Product Change Notification

Date Issued :	February 28, 2022	PCN Number :	511208
Reason for Change :	Change Supplier		
Description of Change :	<p>This notification is to inform you about change of supplier from Polyplastics to WOTE and resin LCP 30% GF BLACK& Natural UL94V-0 unchanged Reason:Polyplastics don't give Molex Shanghai any volume in CY22 Q2 due to capacity shortage, we need to qualify local LCP supplier Wote to meet ramp-up demand Impact: Resin 899920212 (POLYPLASTICS - LAPEROS E130I - BLACK) and 899920213 LCP 30% GF NATURAL UL94V-0</p> <p>Implement change: Validation of supplier change"</p>		
Reason for Short Notice :	Special Request		
Assessment of Change :	First Article Inspection		
Planned Implementation Date :	March 28, 2022		
Sample Availability Date:	March 10, 2022		
Internal Molex Qualification Date :	March 15, 2022		
Last date to request Samples by Customer :	March 20, 2022		
Traceability Code Markings / Date :	Date code

Product Picture

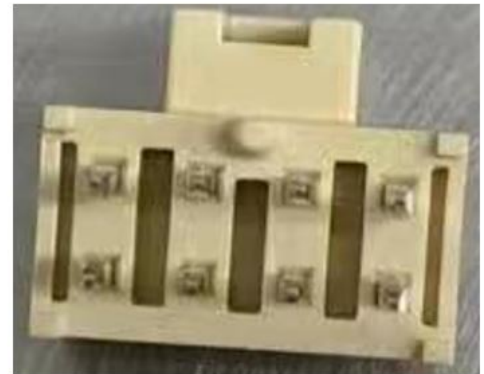
- Due to existing resin supplier Poly plastics capacity constraint issue, we must qualify second resin source to meet ramp-up demand. Current supplier Poly plastics don't supply any volume from CY22 Q2 due to their limited capacity. We must qualify local LCP supplier Wote to avoid production line-down, Wote is top one local LCP supplier in China.

- Product Impact
 - no impact to fit, form or function

- We only change LCP resin supplier but the resin LCP 30% GF BLACK & NATURAL UL94V-0is not changed
 - ✓ Before: Polylactics LCP E130i
 - ✓ After: Wote LCP KD130i
